**ADDENDUM NO. 1**

**MLK ELEMENTARY SCHOOL  
TRANSITIONAL KINDERGARTEN  
BAKERSFIELD CITY SCHOOL DISTRICT**

**Project No.: 5593  
DSA File No. 15-6  
DSA App No. 03-123900  
December 20, 2024**

Sheet No.: **M2.12**

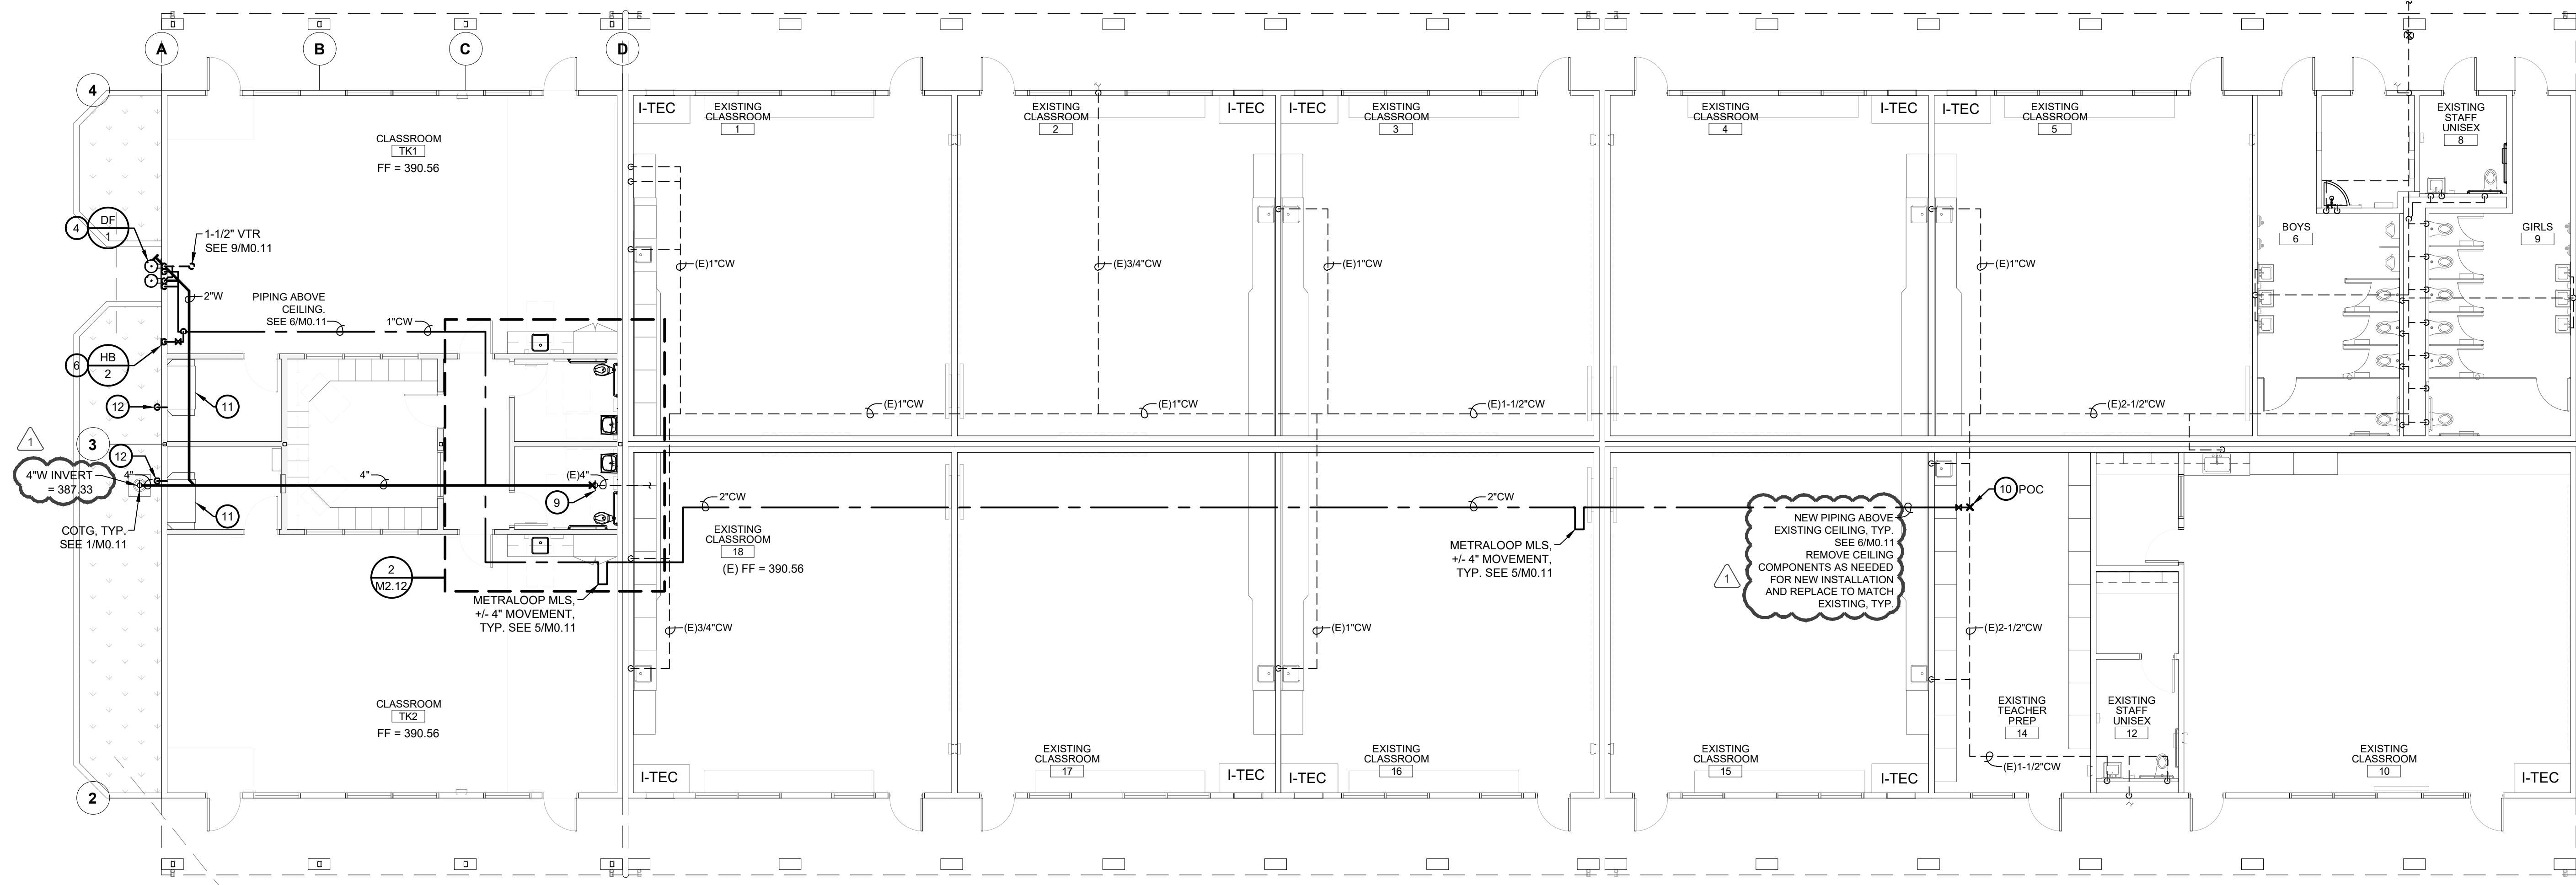
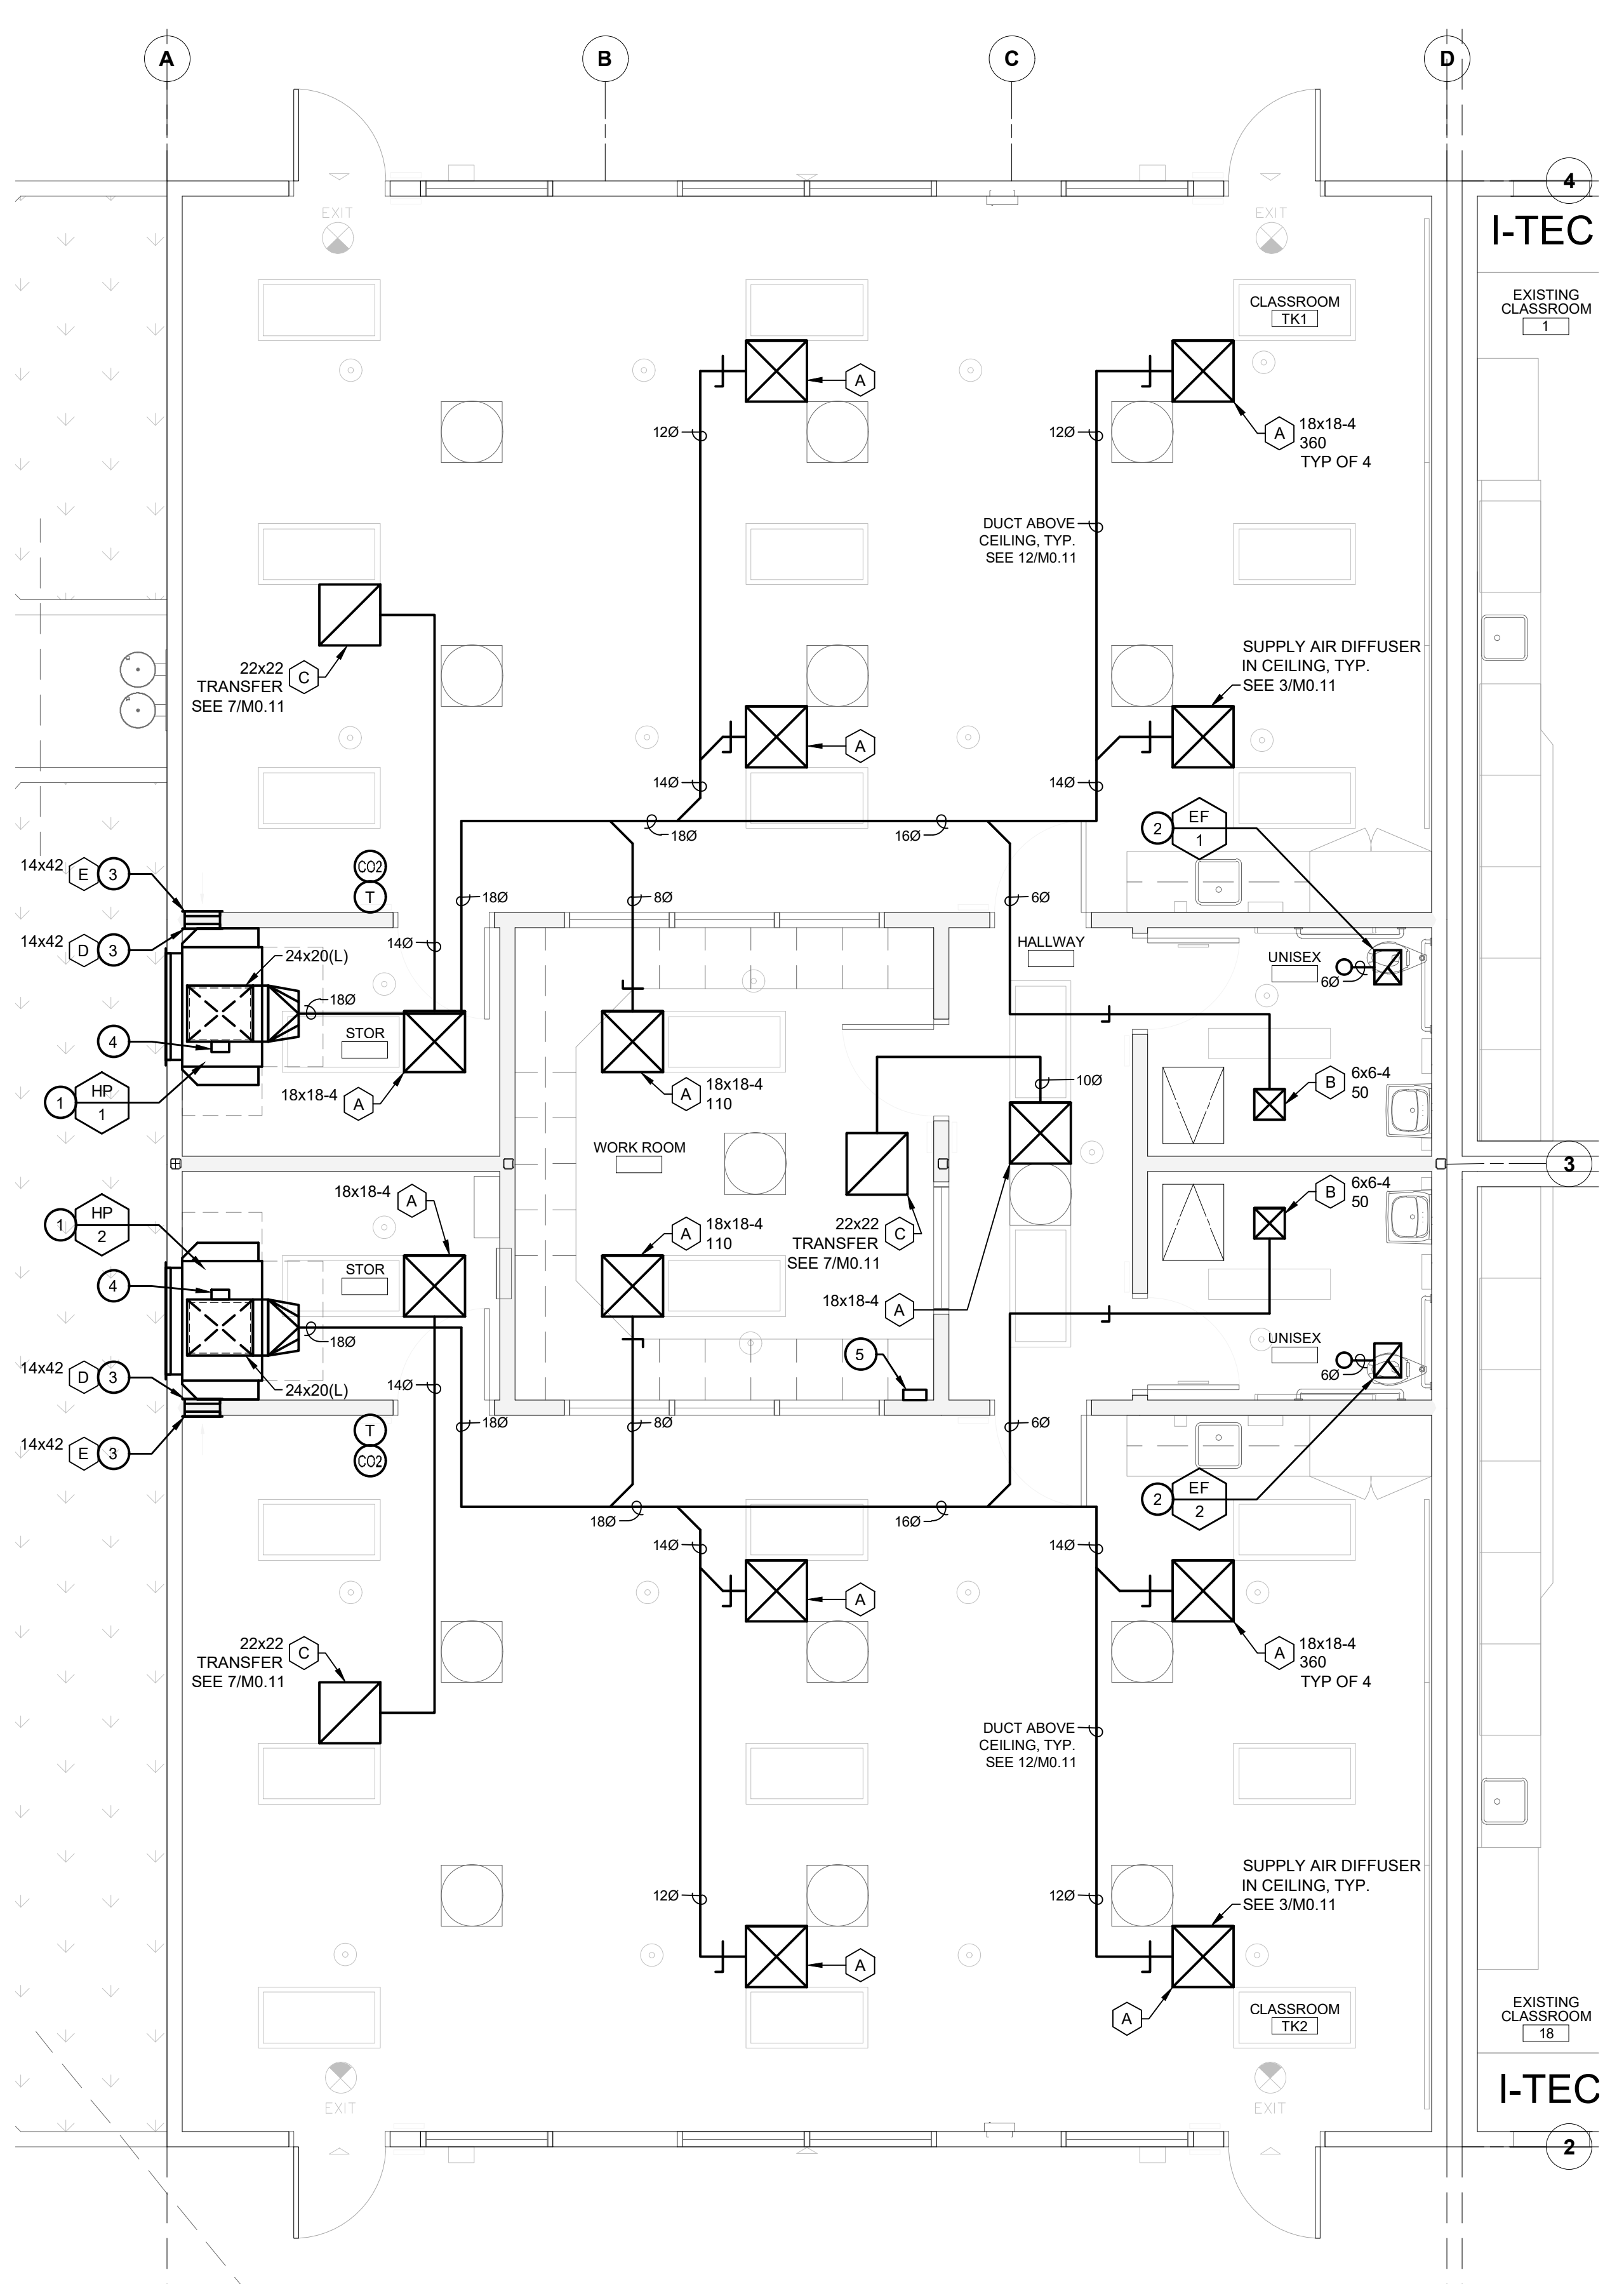
**1-12 DRAWING, SHEET M2.12 – MECHANICAL PLAN – PLUMBING:** Note the following changes (See M2.12 addendum 1 drawing):

1. Modify keynote 3.
2. Add note in room 15.

Sheet No.:  
**E1.00**

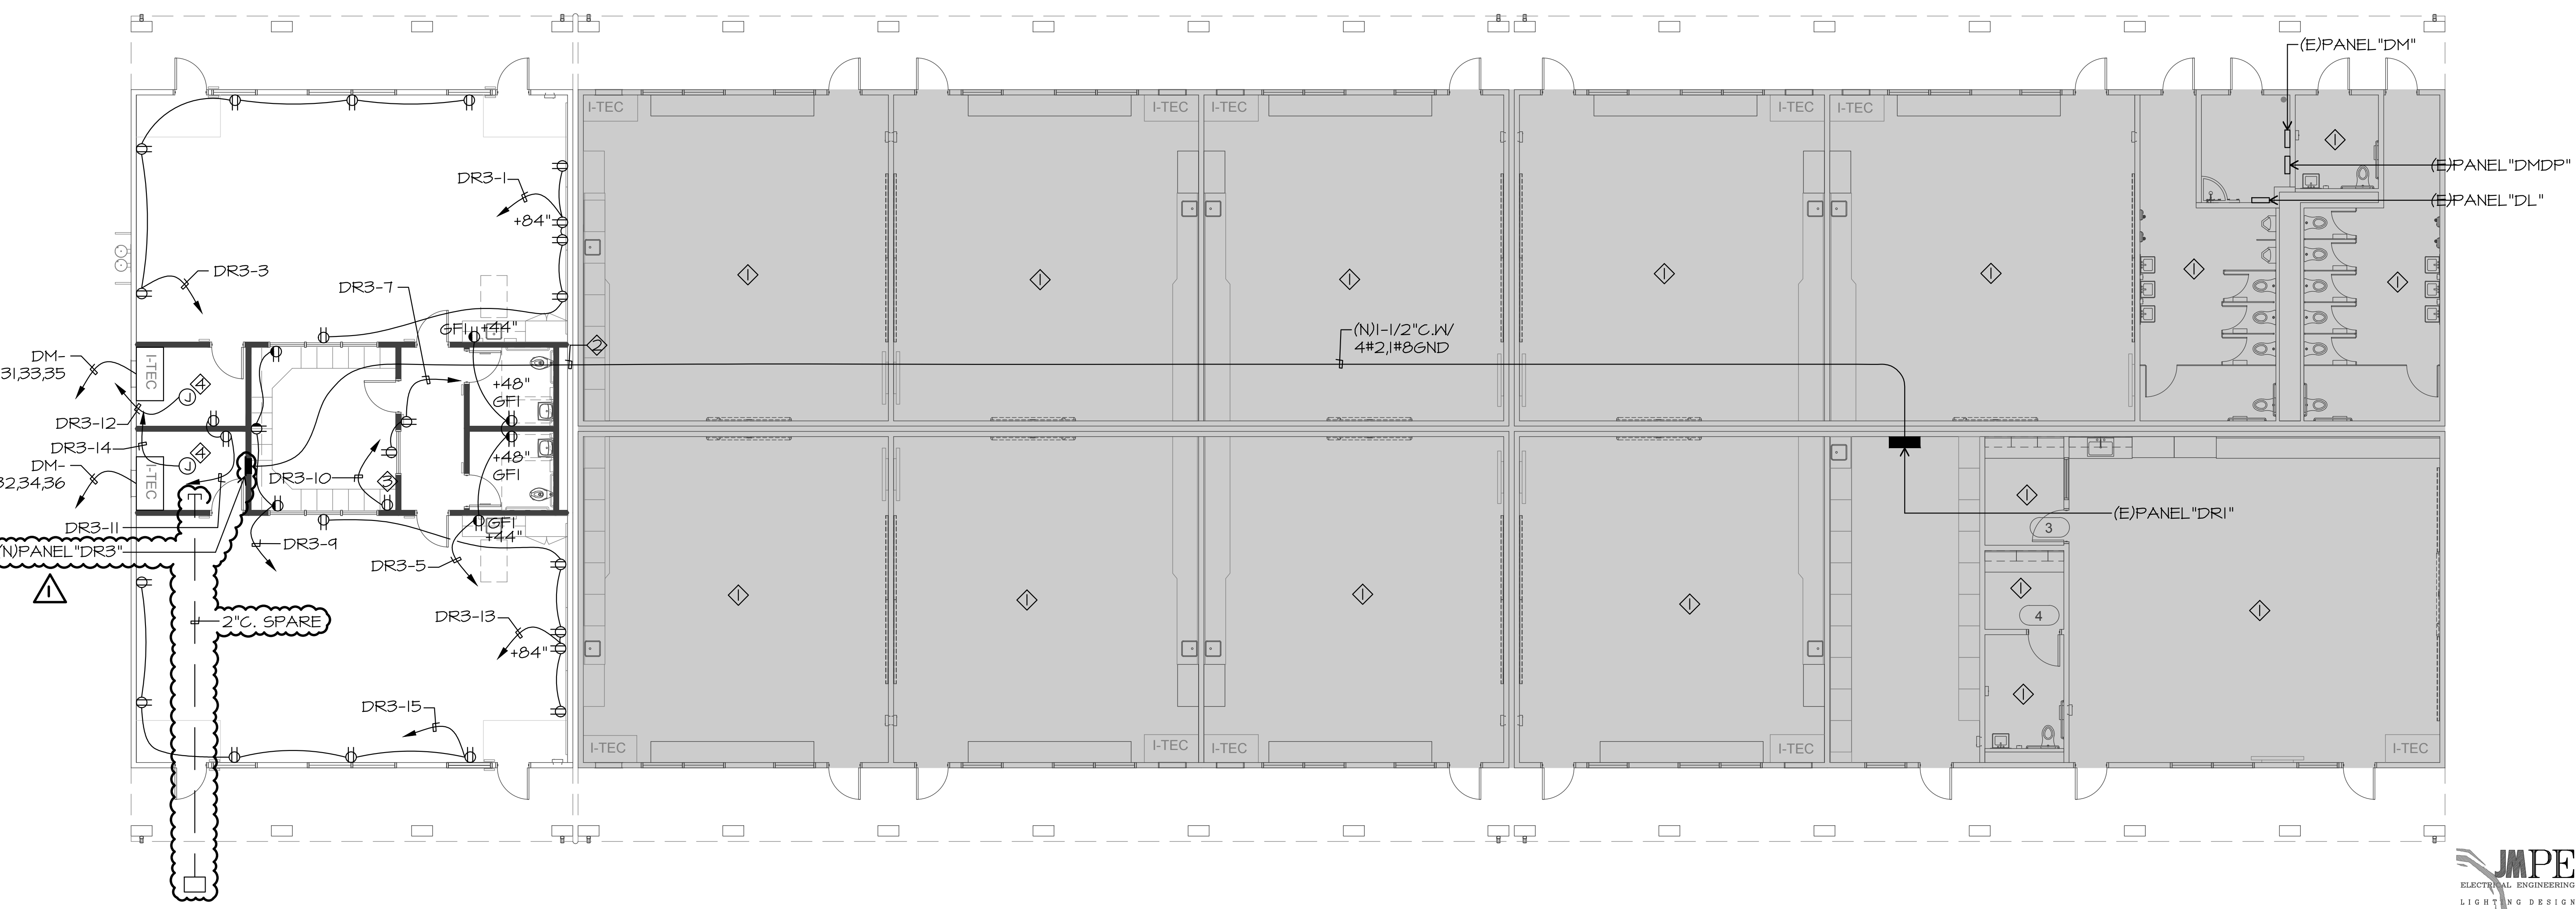
**1-15 DRAWING, SHEET E-4.0 – ELECTRICAL FLOOR PLAN:** Note the following changes (See E4.0 addendum 1 drawing):

1. Add electrical notes 3 and 4.
2. Add IDF to storage room..
3. Add spare conduit and pull box.
4. Update data outlets

Sheet No.:  
**E1.03**

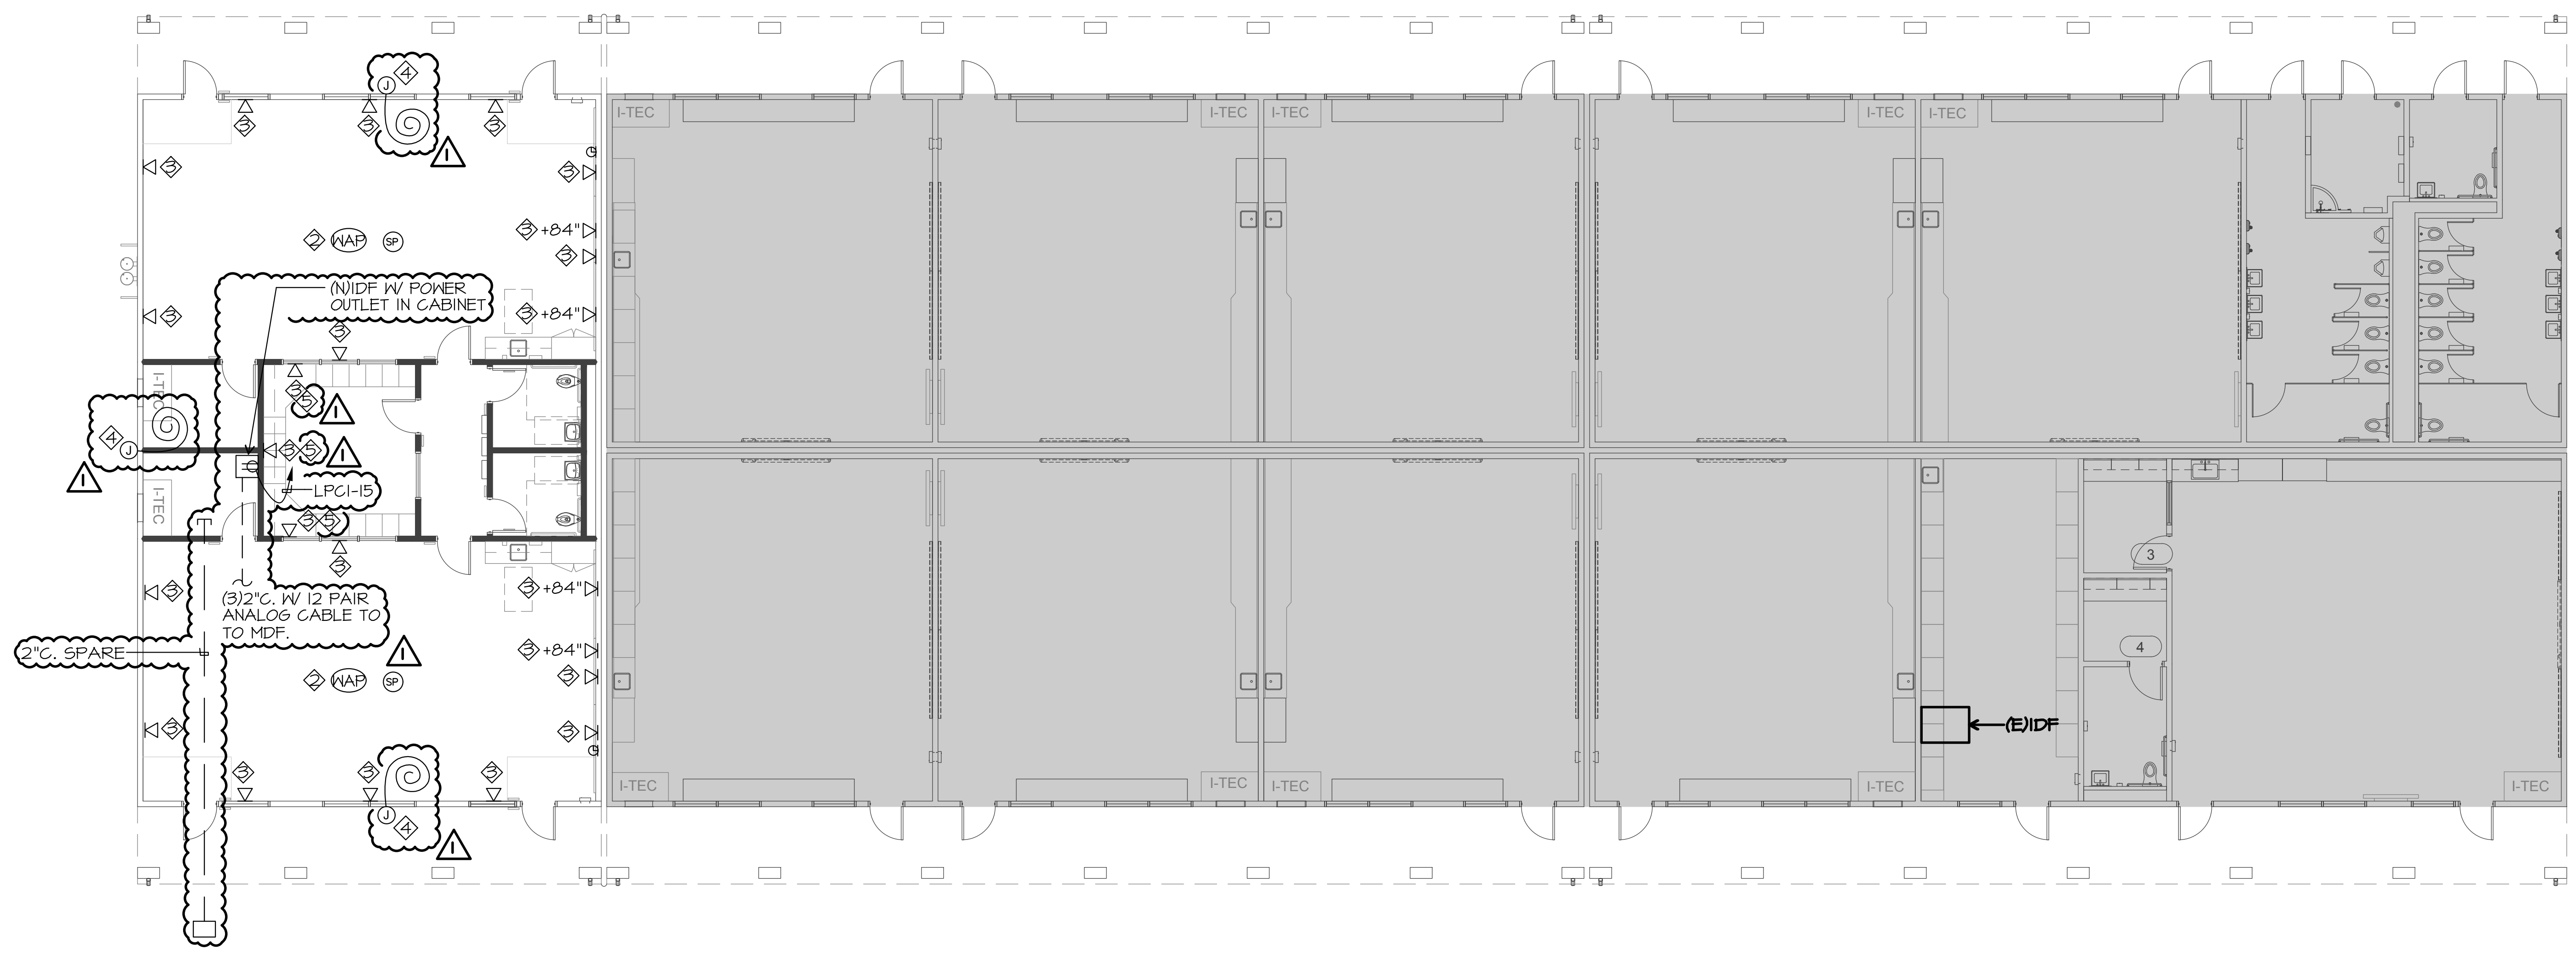
**1-14 DRAWING, SHEET E-1.03 – DATA AND COMM PLAN:** Note the following changes (See E1.03 addendum 1 drawing):

1. Add spare conduit and pull box
